ALERT SERVICE BULLETIN

NO. 412-01-109

MODEL AFFECTED: 412EP

SUBJECT: INTERFERENCE BETWEEN THE DUAL-LAMP SEARCHLIGHT AND FLIGHT CONTROLS, MODIFICATION TO CORRECT

FIGURE 1

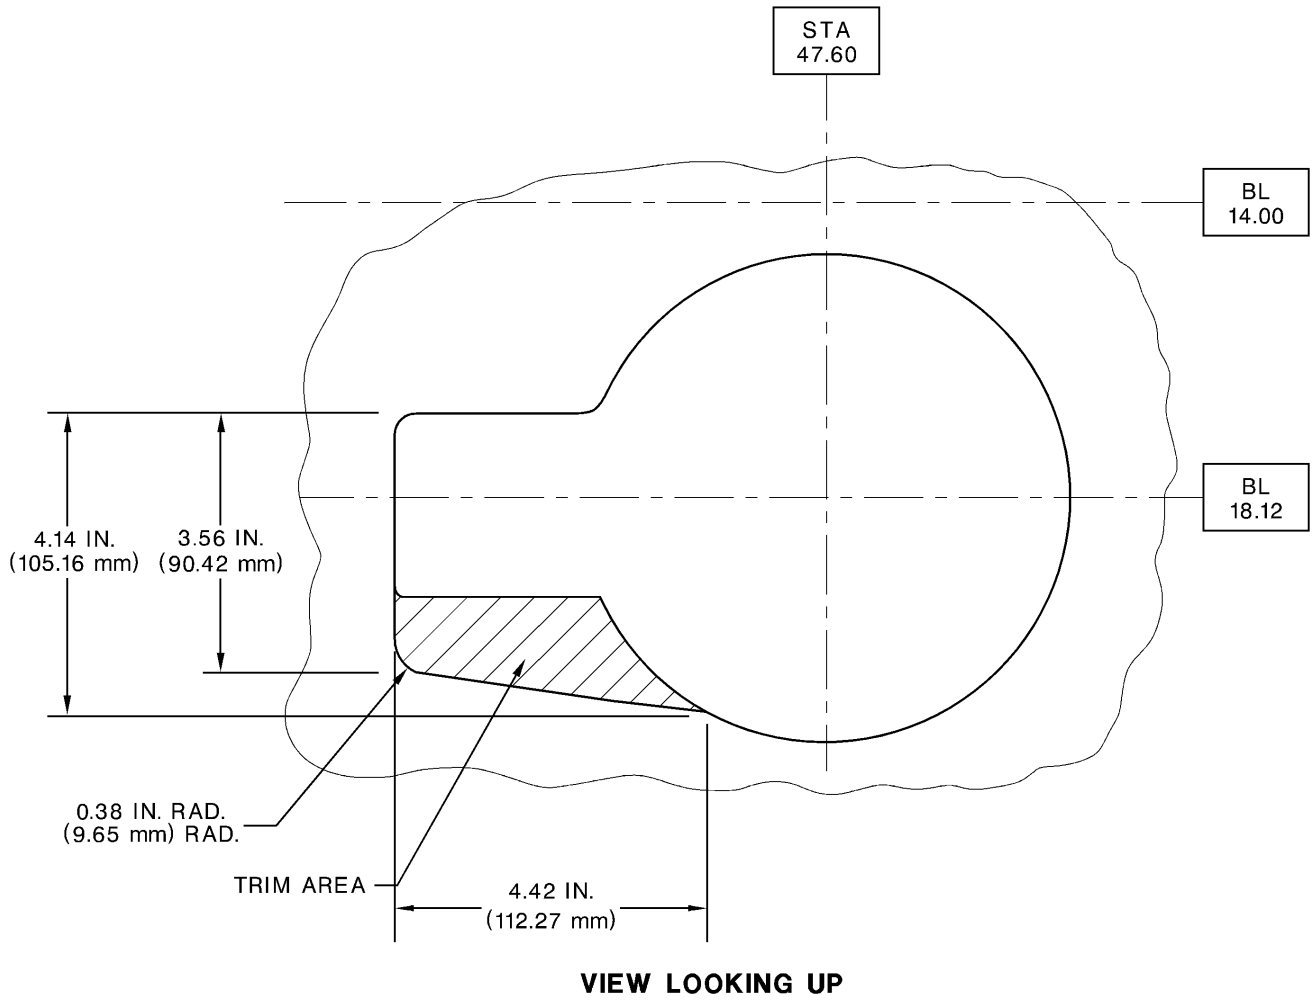
7. Remove doubler P/N 205-032-159-025 and spacers from the forward portion of the searchlight opening.
8. Layout and enlarge the searchlight opening in accordance with Figure 1.

FIGURE 2

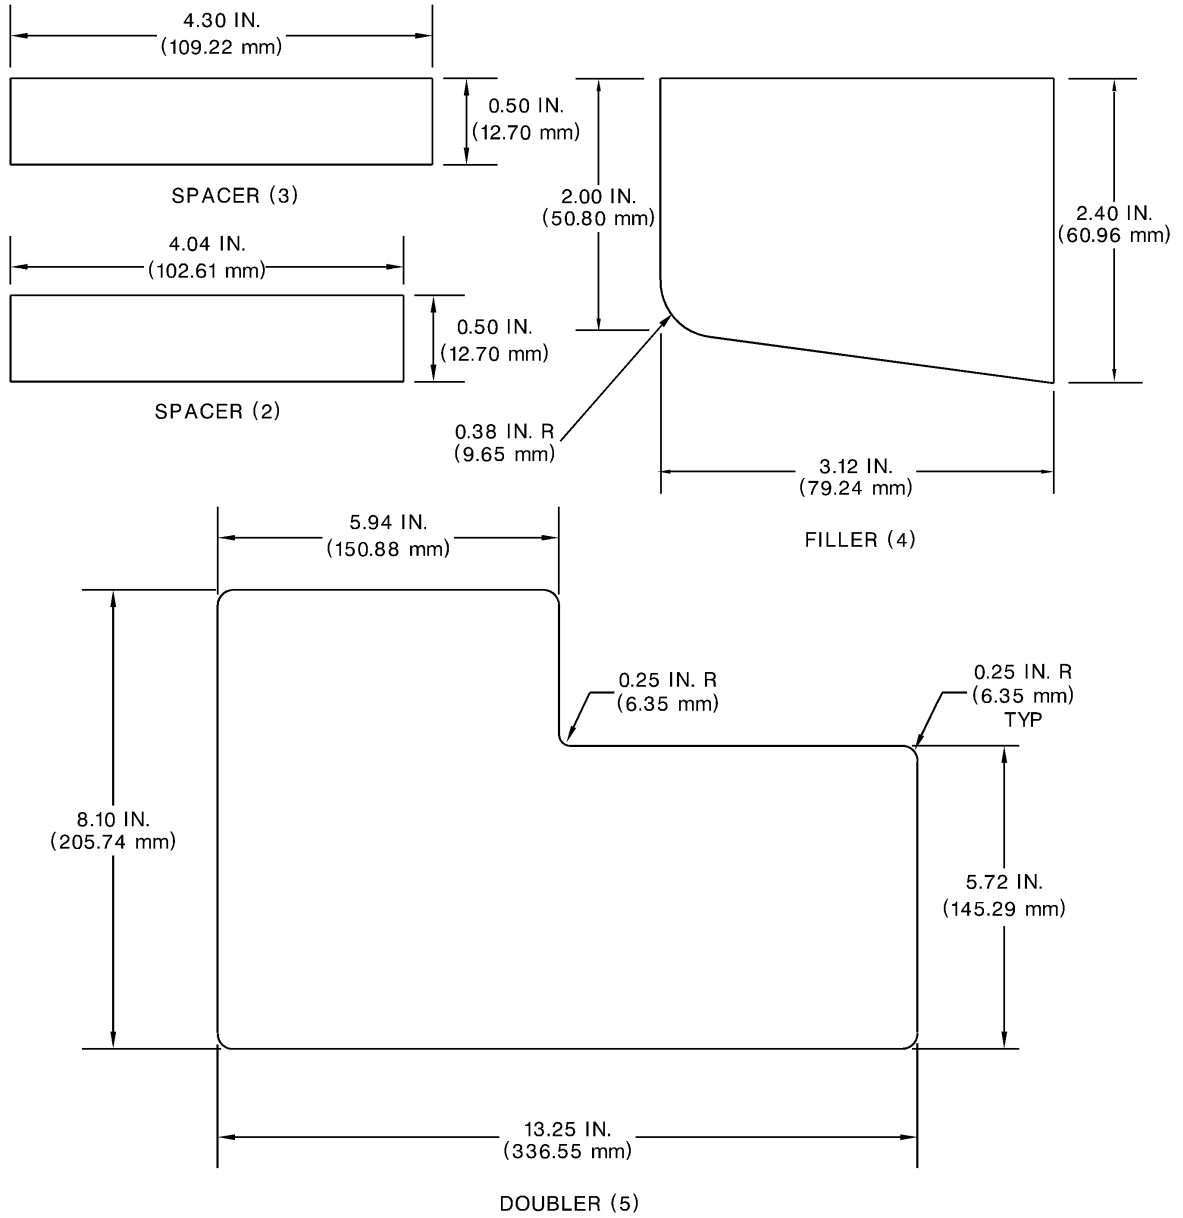
9. Fabricate spacers (2) & (3), filler (4) and doubler (5) as per Figure 2.
10. Install spacers (2) & (3) on doubler P/N 205-032-159-103 (1) in accordance with Figure 3, (with countersink (CSK) on both sides).

FIGURE 3 (Sheet 1)

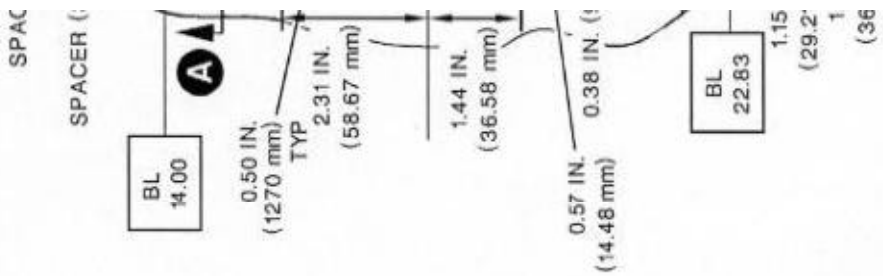
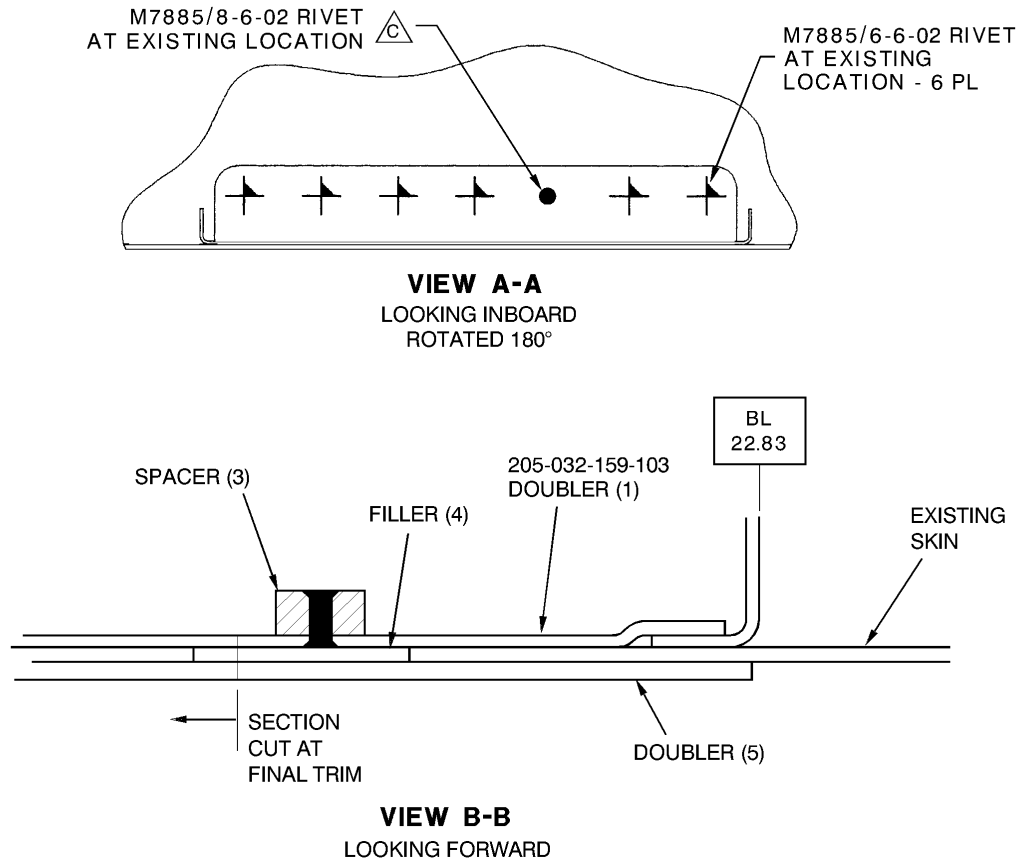
There are six holes noted B on Figure 3; five are forward of the opening and one is aft of the opening. Out of the five holes that are forward of the opening, one is already drilled. Verify for a minimum edge distance of twice the rivet diameter (2D) after final trim.

11. Position filler (4), doubler assembly (1) on the topside of the skin and doubler (5) on the bottom side of the skin. Pilot-drill in accordance with Figure 3 except for holes noted (note B). Attach with clecos.
12. Cut the new searchlight opening and drill (qty 4) attaching holes in accordance with Figure 4.
13. Drill (qty 6) holes (noted B on Figure 3), maintaining a minimum edge distance of 2D and open all rivet holes to final size.
14. Remove all parts, deburr, treat with chemical treatment (C-100) and apply primer (C-204).
15. Install all parts in accordance with Figure 3.
